Access Compliance Report

Public Rights-of-Way

(Curb Ramps)

Intersection ID: 48475	Main Street: SHALLOW_OAK_CT	Cross Street: AUTUMN_OAK_DR	Location: S
ADA ID: CFE25CC5CDEE	Ramp Type: Perp	Initial Pass/Fail: Fail	Overall Compliance: No
Severity Score: 35			
Codes/Mitigation Info/Possible Solution		Field Measurements/Component Compliance

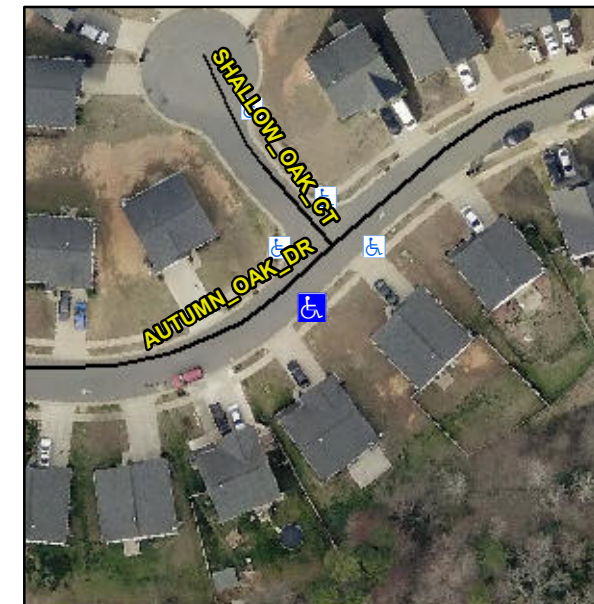
Not Found, R304.5.1, R304.2.2

Compliance	Description	Data	Compliance	Description	Data
N/A	Ramp Length (in)	46.0	No	Ramp Slope (%)	15.6
No	Ramp Width (in)	47.5	Yes	Ramp XSlope (%)	3.5
N/A	Flare Type LT	N/A	N/A	Flare Type RT	N/A
N/A	Flare Slope LT (%)	N/A	N/A	Flare Slope RT (%)	N/A
N/A	Flare Traversable LT?	N/A	N/A	Flare Traversable RT?	N/A
N/A	Landing Length (in)	N/A	N/A	DWS Provided?	N/A
N/A	Landing Width (in)	N/A	N/A	DWS Contrast?	N/A
N/A	Landing Slope (%)	N/A	N/A	DWS Length (in)	N/A
N/A	Landing X Slope (%)	N/A	N/A	DWS Full Width?	N/A
N/A	Landing Curb? (Y/N)	N/A	N/A	DWS Offset (in)	N/A
N/A	Shared Landing?	N/A			
N/A	Gutter Ponding?	N/A	N/A	Gutter Slope (%)	N/A
N/A	Gutter Lip Ht (in)	N/A	N/A	Gutter X Slope (%)	N/A
N/A	Painted X Walk1?	No	N/A	Painted X Walk2?	N/A
	X Walk 1 Direction	To NW		X Walk 2 Direction	N/A
N/A	X Walk 1 Width (in)	N/A	N/A	X Walk 2 Width (in)	N/A
	X Walk 1 Slope (%)	1.0		X Walk 2 Slope (%)	N/A
	X Walk 1 X Slope (%)	4.4		X Walk 2 X Slope (%)	N/A

Remove & Replace Entire Ramp.
